Rezoning Application: PD 22-1703

Zoning Hearing Master Date: May 15, 2023

APPLICATION NUMBER: PD 22-1703

RE: Graves Road Apartments (PD 22-1703)
Folio: 067906-0010, 067907-0000, 067911-0000, 06906-0000
Design Exception – Graves Road
Palm Traffic Project No. T22091

Figure 1: Existing PD 05-0809

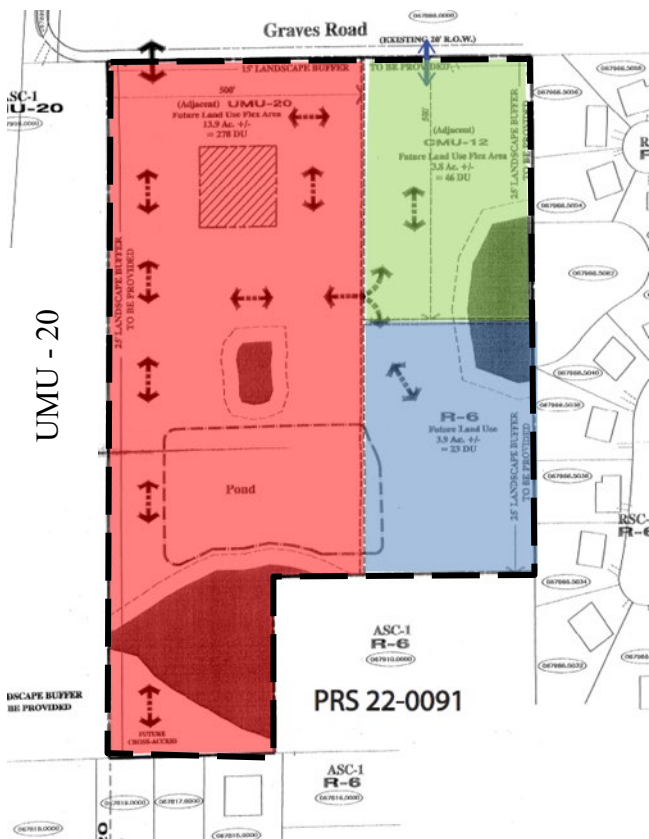
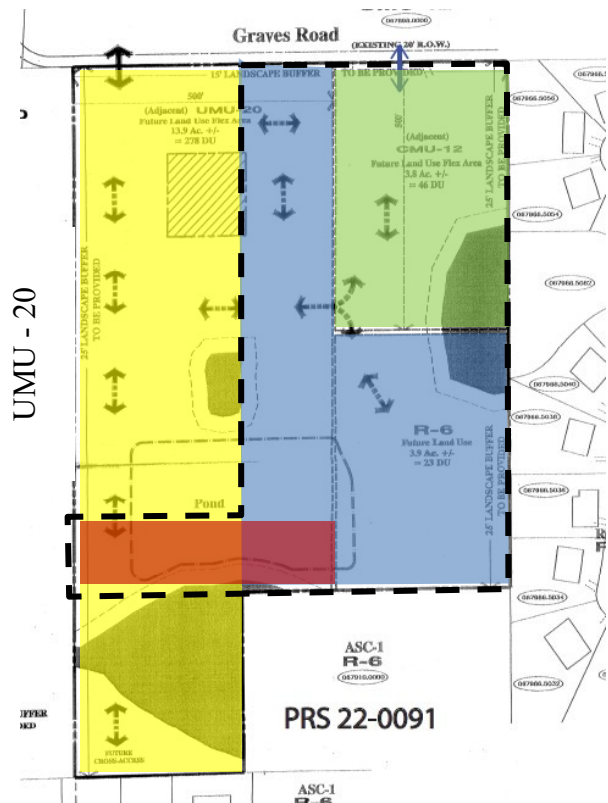
Figure 1 shows the FLU categories within the existing PD. The entire PD is located within the RES-6 FLU category. The red area depicts the UMU-20 flex that occurred from property to the immediate west of PD 05-0809 (13.9 acres). The green area depicts the CMU-12 flex that occurred from the north of PD 05-0809 (3.8 acres). The blue area depicts the area that remained in the RES-6 FLU category (3.9 acres).

Figure 2 shows how PD 05-0809 will be modified due to the proposed rezoning. The area to be removed under this PD request is shown in yellow. The CMU-12 flex (shown in green) remains and is not impacted by the removal. In order to maintain the UMU-20 flex and the units it provides, a strip of land (shown in red) will remain connecting the UMU-20 FLU parcel to PD 05-0809. The remainder of PD 05-0809 will be within the RES-6 FLU category. The calculations are as follows: CMU-12 (3.8 acres) = 45 units, UMU-20 (0.95 acres) = 18 units, RES-6 (7.41 acres) = 44 units, totaling 107 units over the development area of 11.55 acres (9 units per acre). Additionally, the remaining area under PD 05-0809 has full access to Graves Road and is not dependent on the removed acreage for access.

8.0 PROPOSED SITE PLAN (FULL)

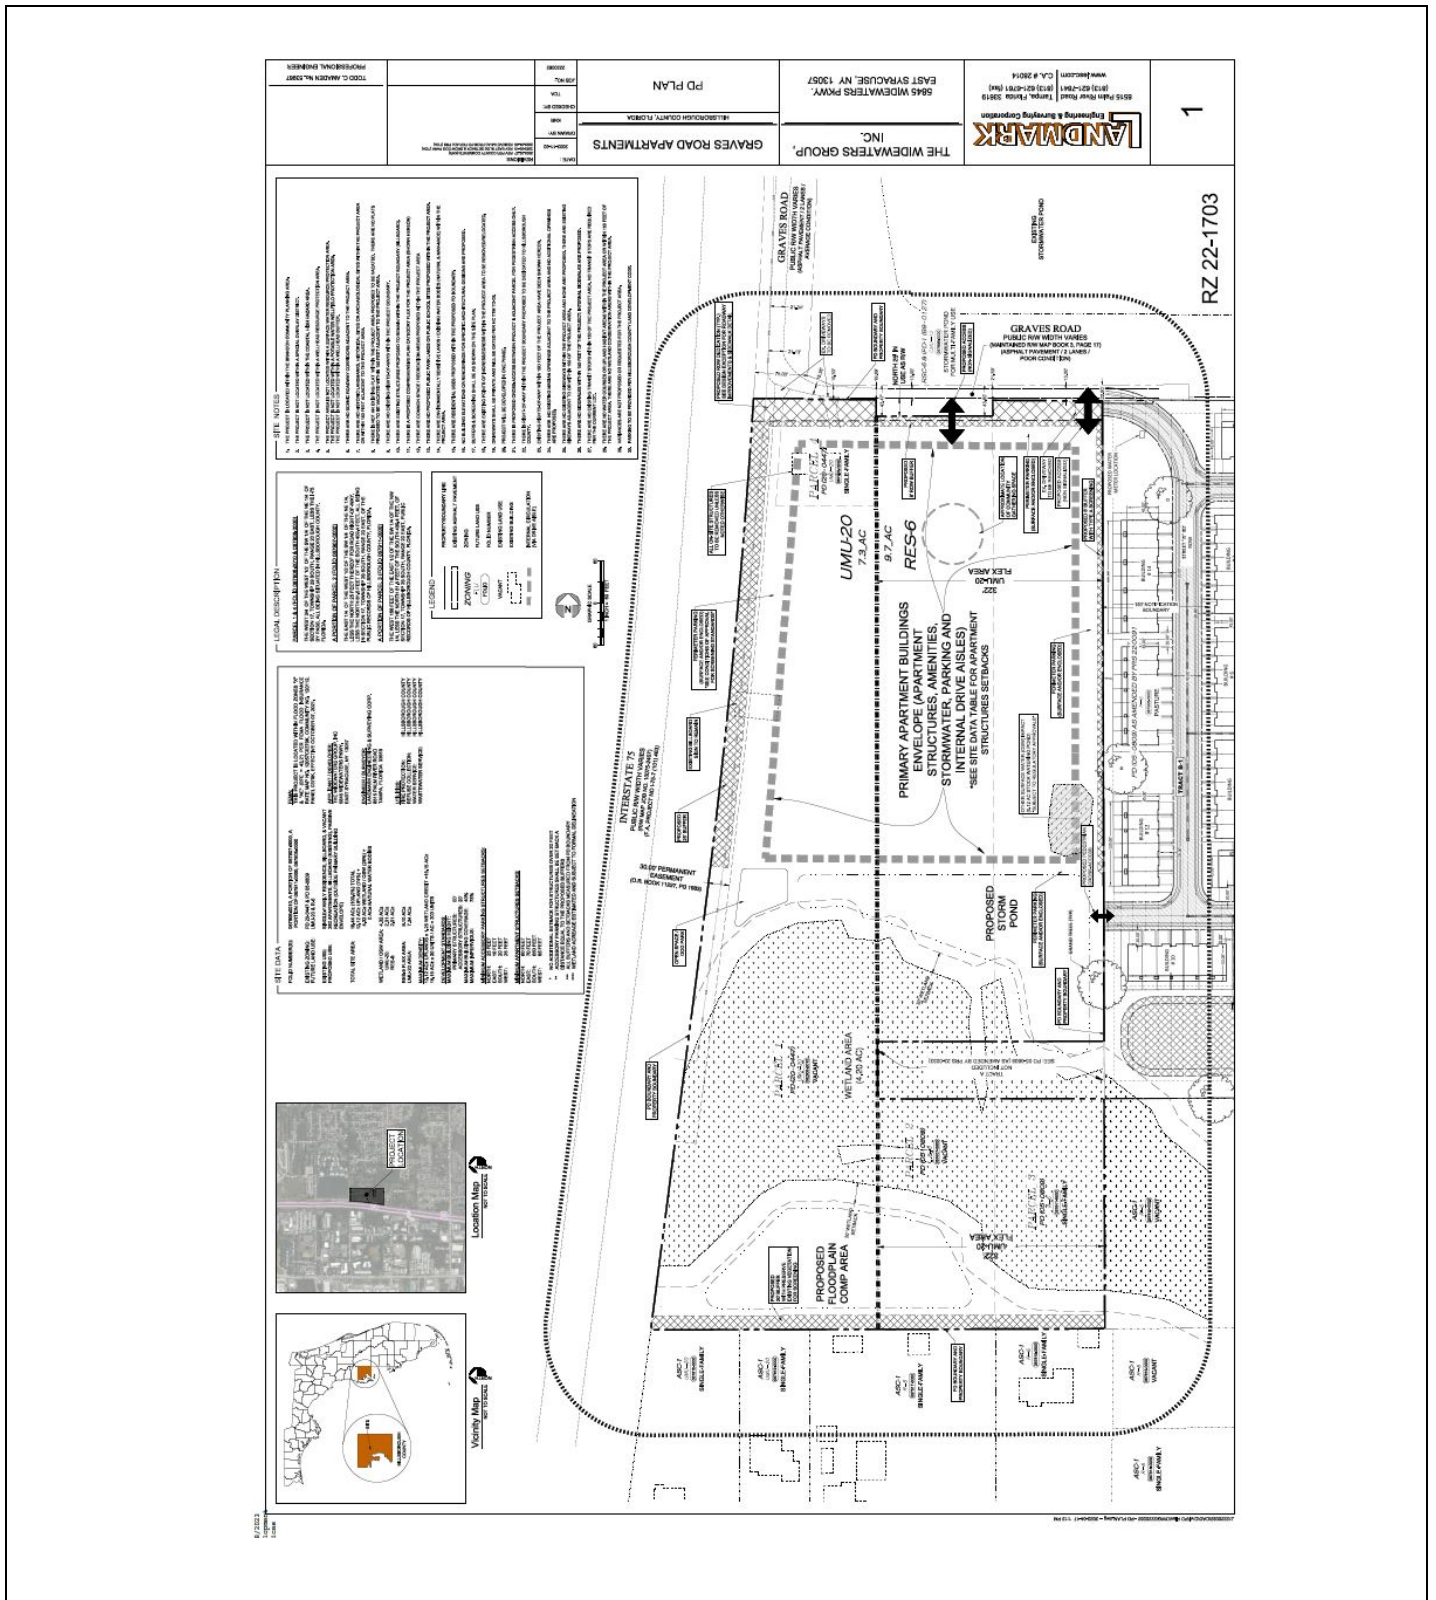
1. Site Data Table to correct the flex area from RES-6 to UMU-20.
2. Accessory structure southern setback to be revised – distance from PD boundary needed.
3. Site Plan to remove delineation and notation of existing billboard.
4. Correct RES-6 acreage on site plan from 9.7 acres to 9.1 acres.
5. Add a Note to the site plan that reads “Sidewalks to be provided per the Hillsborough County Land Development Code.”

- Add a Note to the site plan that reads “Sidewalks to be provided per the Hillsborough County Land Development Code.”

FIGURE 2. ROADWAY SEGMENTS

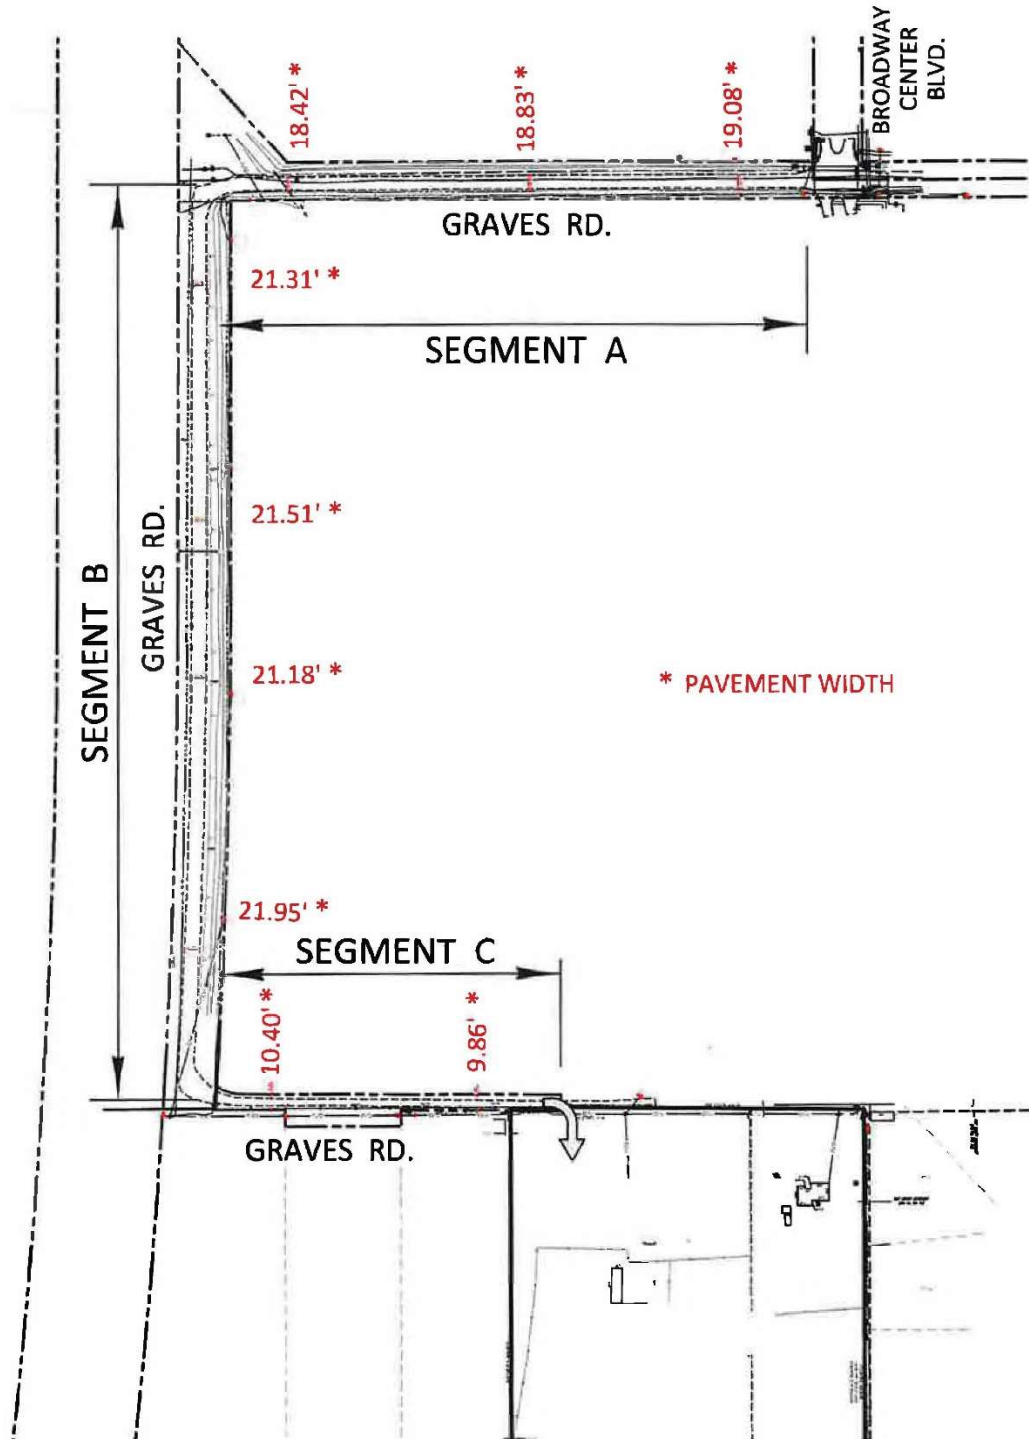
Graves Road is broken into three segments for the design exception request:

- Segment A – This segment is from Broadway Center Road to the northern north/south portion of Graves Road
- Segment B – This segment is the north/south portion of Graves Road, parallel to I-75
- Segment C – This segment is from the north/south portion to the eastern project access.

These segments are shown in Figure 2.

I have found the attached Design Exception (DE) for PD 22-1703 APPROVABLE. It should be noted that improvements associated with PI 6103 listed in the DE will become the responsibility of this project should the other project not move forward.

**FIGURE 3. PROPOSED TYPICAL SECTIONS
GRAVES ROAD**

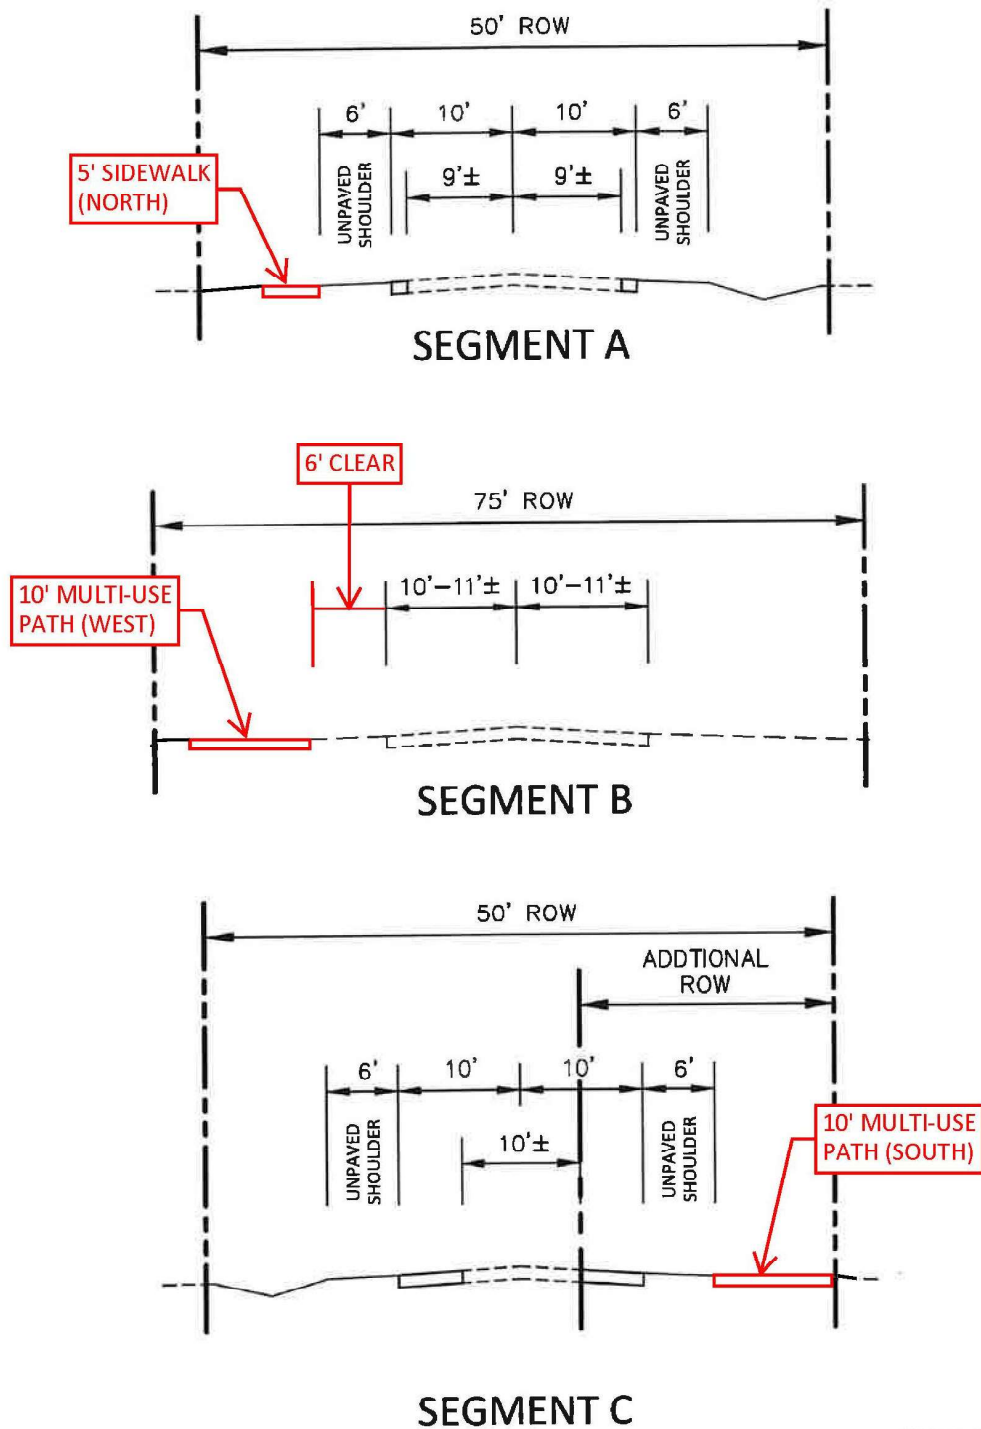
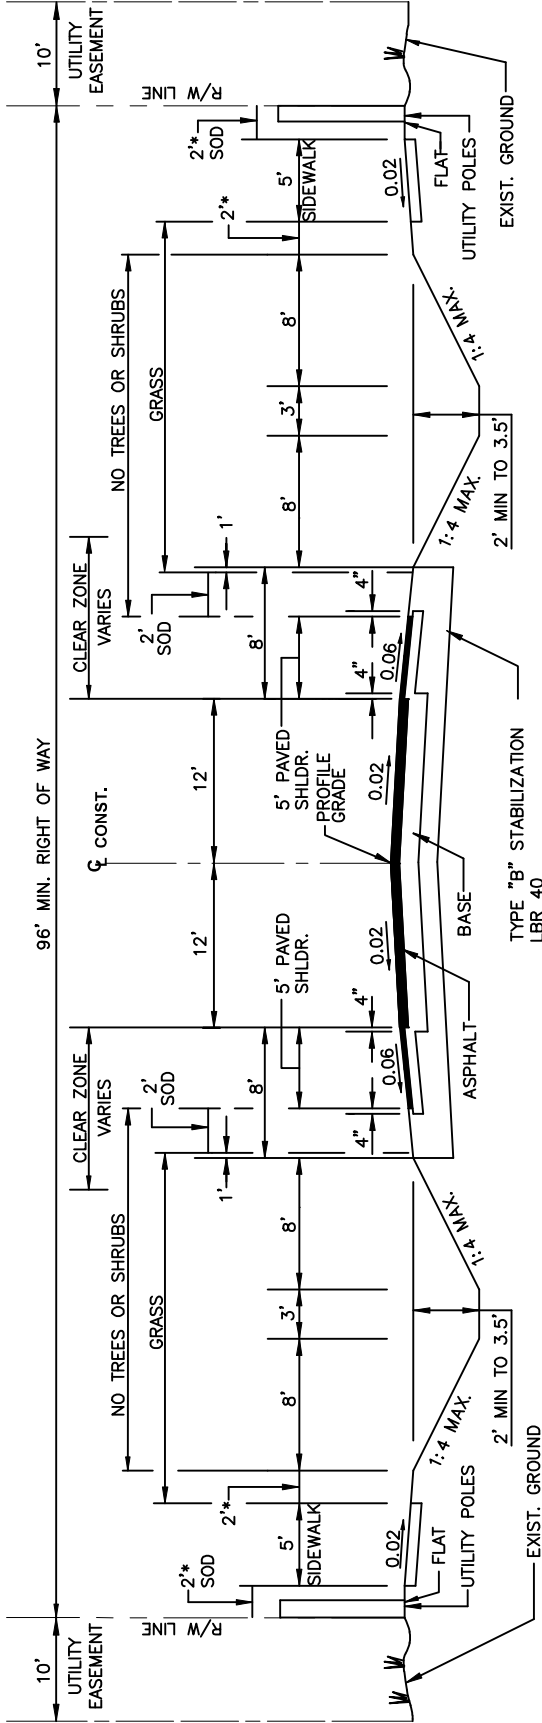
This request is a design exception to the Hillsborough County Transportation Technical Manual for Graves Road from Broadway Center Road to the eastern access of the subject site. The requested exceptions to the TS-7 typical for each section and the justification are as follows:

Segment A

1. Lane Width – TS-7 has 12-foot travel lanes. The existing lanes are approximately 9 feet. The proposed section has 10-foot travel lanes. This modification is currently under plan review PI 6103.
2. Shoulder – TS-7 has 8-foot shoulders with 5-foot paved on both sides of the roadway. The existing roadway has limited to no shoulders. Due to limited right of way, the full shoulder cannot be provided, however, a 6-foot unpaved shoulder is proposed to be provided on both sides of the roadway. This modification is currently under plan review, PI 6103.
3. Sidewalk – TS-7 has a 5-foot sidewalk on both sides of the roadway. Due to limited right of way, a 5-foot sidewalk is proposed on the north side of Graves Road. This will connect to the existing sidewalk along Broadway Center Boulevard.

Segment B

1. Lane Width – TS-7 has 12-foot travel lanes. The existing lanes are approximately 10 feet to 11 feet. This section proposes to maintain the existing lane widths. However, at the request of FDOT, this segment of roadway will be milled and resurfaced.
2. Shoulder – TS-7 has 8-foot shoulders with 5-foot paved on both sides of the roadway. The existing roadway has at least 6-foot unpaved shoulders. This section proposes to maintain the existing unpaved shoulders.
3. Sidewalk – TS-7 has a 5-foot sidewalk on both sides of the roadway. Due to limited right of way, a 10-foot multi-use path is proposed on the west side of Graves Road.

Segment C

1. Right of Way – TS-7 has 96 feet of right of way. The proposed right of way is 50 feet which will accommodate the proposed typical section.
2. Lane Width – TS-7 has 12-foot travel lanes. The existing roadway is approximately 10 feet. The proposed section has 10-foot travel lanes. This modification is currently under plan review PI 6103.
3. Shoulder – TS-7 has 8-foot shoulders with 5-foot paved on both sides of the roadway. The existing roadway has limited to no shoulders. Due to limited right of way, the full shoulder cannot be provided, however, a 6-foot unpaved should is proposed to be provided on both sides of the roadway. This modification is currently under plan review, PI 6103.
4. Sidewalk – TS-7 has a 5-foot sidewalk on both sides of the roadway. Due to limited right of way, a 10-foot multi-use path is proposed on the south side of Graves Road.

The proposed typical sections are shown in Figure 3.

DESIGN EXCEPTION, SUBSTANDARD ROAD – GRAVES ROAD

Given that Graves Rd. is a substandard local roadway, the applicant’s Engineer of Record (EOR) submitted a Design Exception (DE) request (on March 28, 2023) for Graves Road. to determine the specific improvements that would be required by the County Engineer. Based on factors presented within the Design Exception request, the County Engineer found the DE approvable (on April 4, 2023). The deviations from the TS-7 Typical Section (2-Lane Undivided, Local and Collector Rural Roadways), include:

- The developer shall be permitted to utilize the 10-foot travel lanes in lieu of the 12-foot-wide travel lanes typically required by the Hillsborough County Transportation Technical Manual (TTM) TS-7;
- The developer shall be permitted to utilize 6-foot unpaved shoulders on each side of the roadway in lieu of the 8-foot shoulder with 5 feet paved typically required by the Hillsborough County Transportation Technical Manual (TTM) TS-7;

- The developer shall construct 5-foot sidewalk on the north side of Graves Road in lieu of the 5 foot wide sidewalk on both sides of the roadway typically required by the Hillsborough County Transportation Technical Manual (TTM) TS-7;

- The developer shall be permitted to utilize the existing 10 to 11-foot travel lanes in lieu of the 12-foot wide travel lanes typically required by the Hillsborough County Transportation Technical Manual (TTM) TS-7. FDOT has required this segment to be milled and resurfaced.
- The developer shall be permitted to utilize 6-foot unpaved shoulders on each side of the roadway in lieu of the 8-foot shoulder with 5 feet paved typically required by the Hillsborough County Transportation Technical Manual (TTM) TS-7;
- The developer shall construct 10-foot multi-use path along the west side of Graves Road in lieu of the 5-foot-wide sidewalk on both sides of the roadway typically required by the Hillsborough County Transportation Technical Manual (TTM) TS-7;

- The developer shall be permitted to utilize the 10-foot travel lanes in lieu of the 12-foot-wide travel lanes typically required by the Hillsborough County Transportation Technical Manual (TTM) TS-7;
- The developer shall be permitted to utilize 6-foot unpaved shoulders on each side of the roadway in lieu of the 8-foot shoulder with 5 feet paved typically required by the Hillsborough County Transportation Technical Manual (TTM) TS-7;
- The developer shall construct 10-foot multi-use path along the south side of Graves Road in lieu of the 5-foot-wide sidewalk on both sides of the roadway typically required by the Hillsborough County Transportation Technical Manual (TTM) TS-7;
